PLANNING COMMISSION MEETING

City of Gardner, Kansas

1. HILLTOP RIDGE

PLANNING COMMISSION STAFF REPORT
MEETING DATE: MAY 26, 2020
PREPARED BY: ROBERT CASE, PLANNER

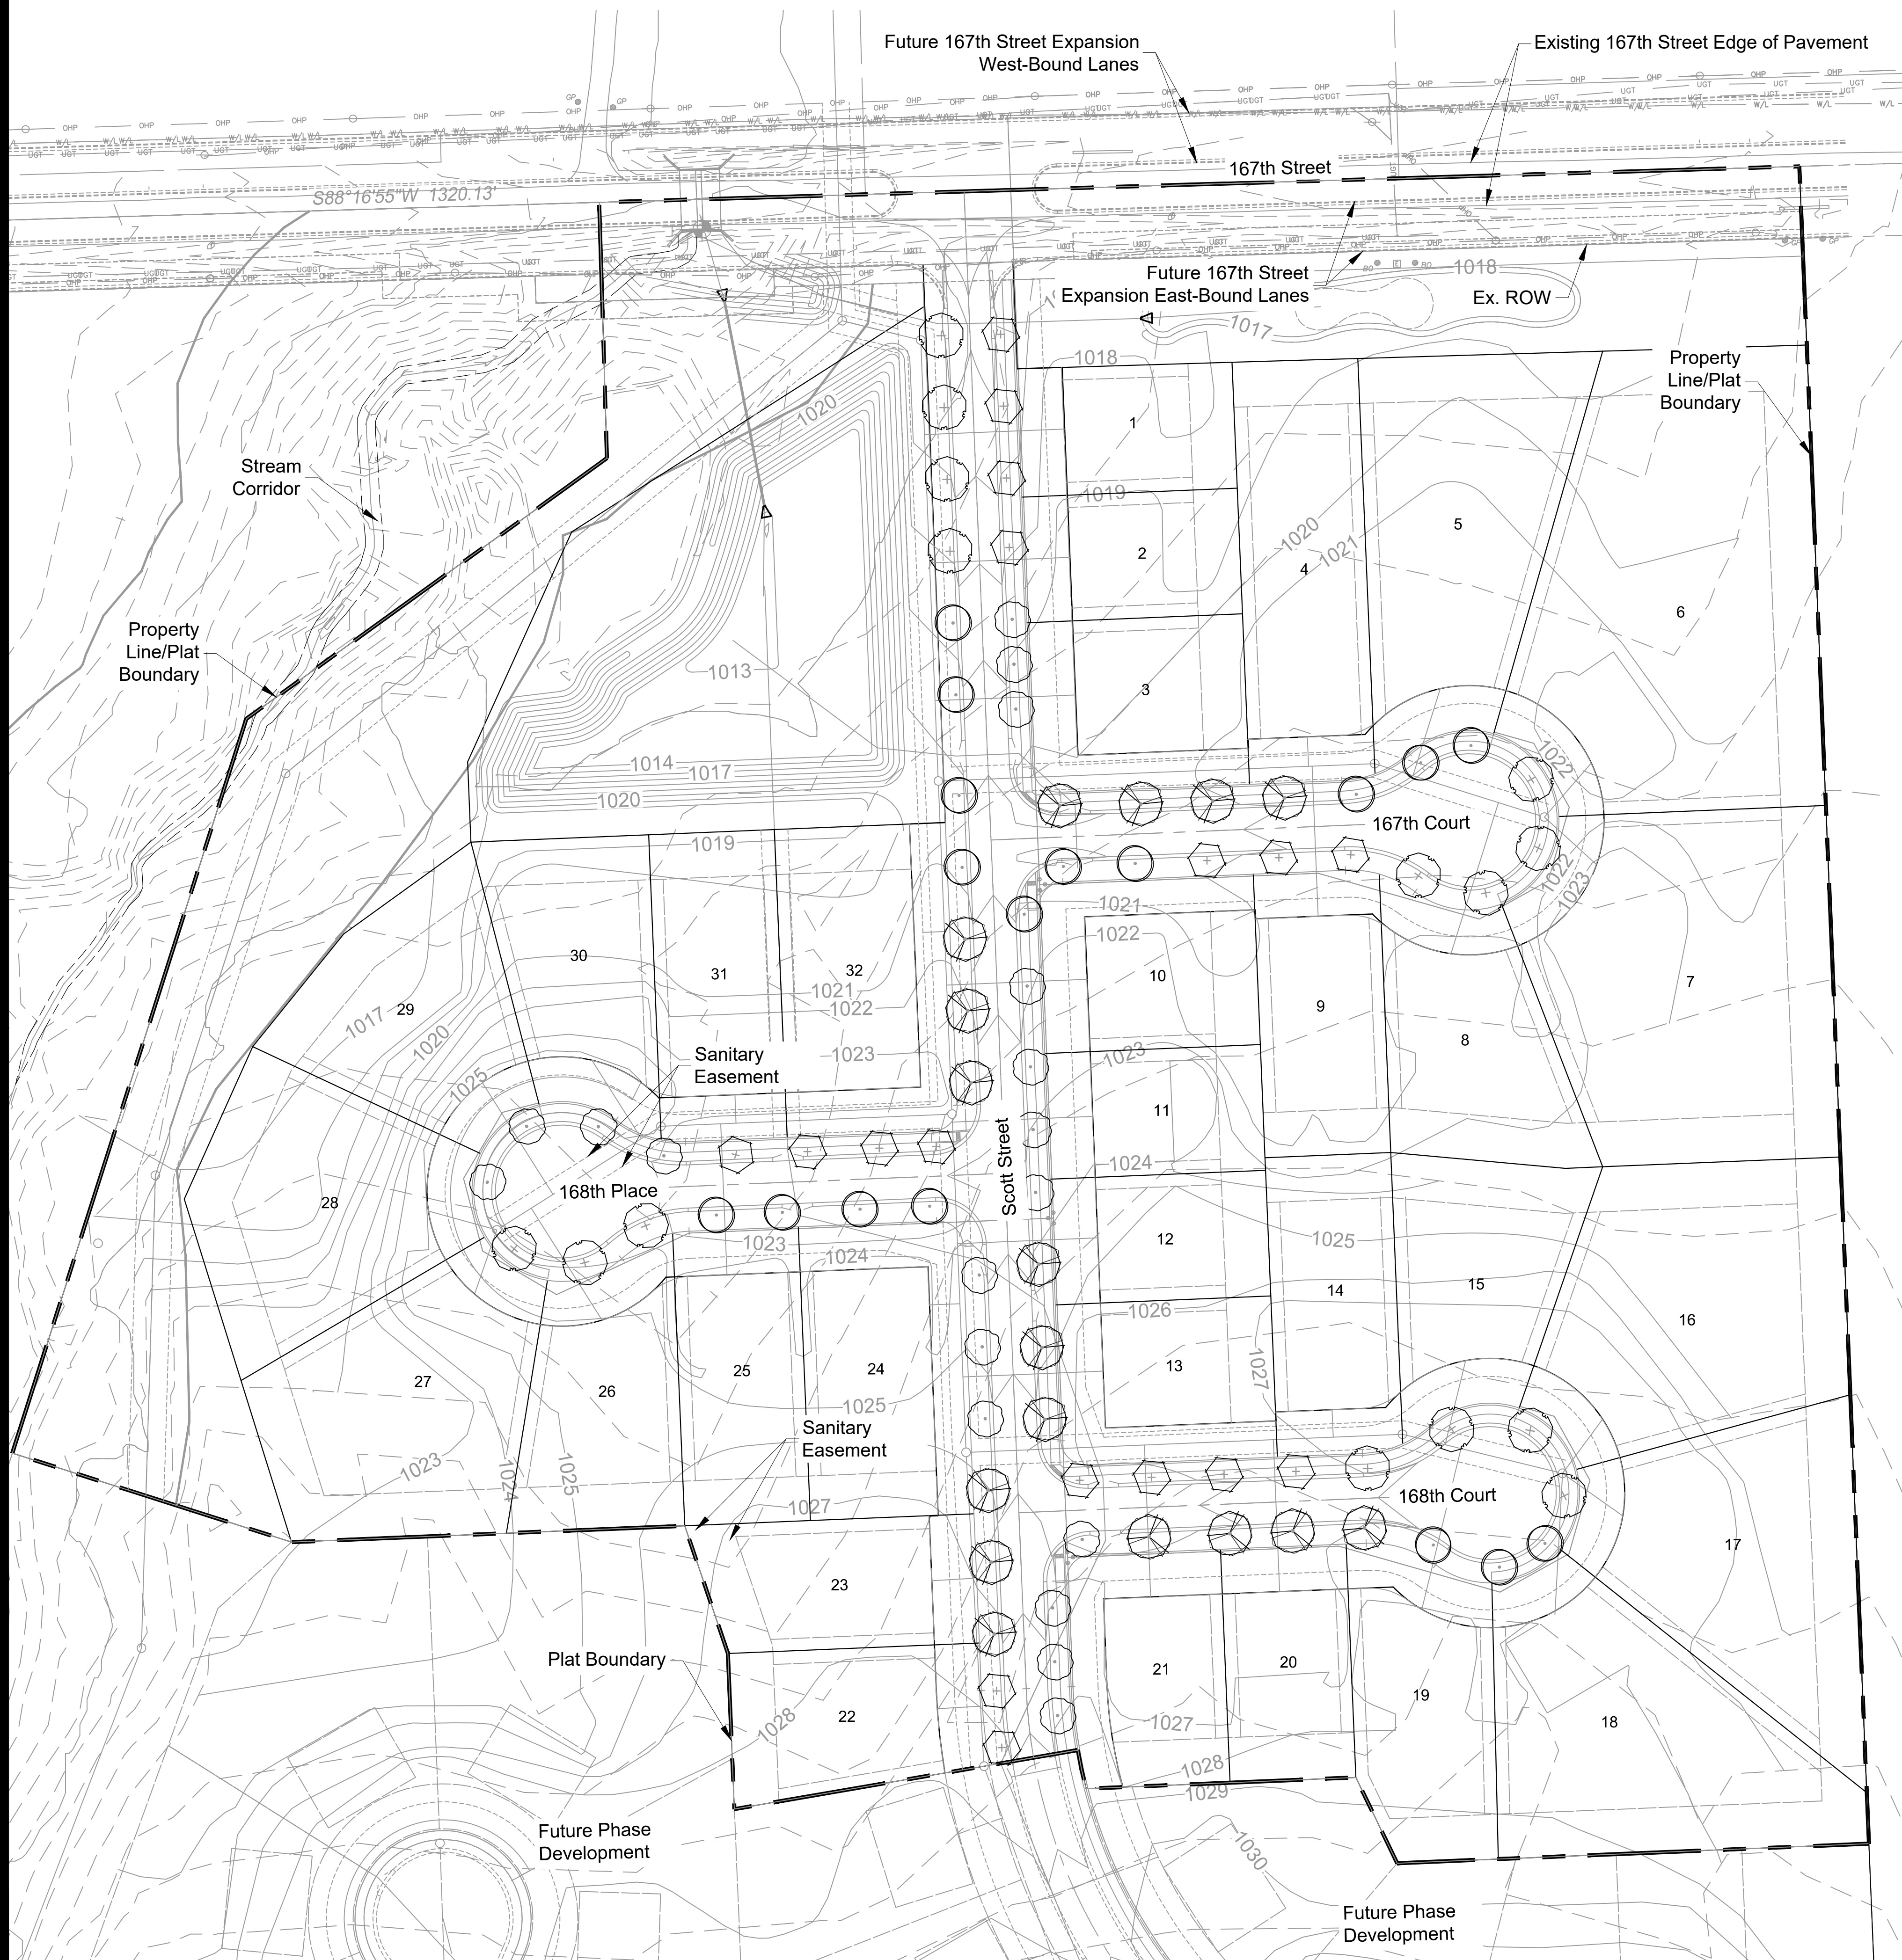
Staff Comment: *The plat meets the site design standards regarding lot size minimum, block length, cul-de-sac length and easements. The plan complies with the requirements of the Gardner Land Development Code in that the blocks and lots proposed can meet all development and site design standards. The development is proposed to be a Detached House - Suburban building type for single-family residential, with a Suburban Yard frontage design type. While this development is within the service area of Celebration Park, they are still dedicating approximately 10% of the space to open and civic space which is private open space. A street tree plan has been submitted and is generally in compliance. A few changes remain to be made to move proposed trees further from intersections. This will be a condition of approval.*

1. Public improvement plans shall be submitted and approved prior to the release of the final plat for recording at the County.
2. Revise the plat to show Hilltop Street to be named Scott Street.
3. Revise the plat to show 168th Street to be 168th Place.
4. Provide a revised street tree plan based on staff comments, for approval prior to the release of the plat for recording.
5. Prior to the recording of the final plat, excise tax shall be paid to the City.
6. Correct square footage of the subdivision on the legal description.
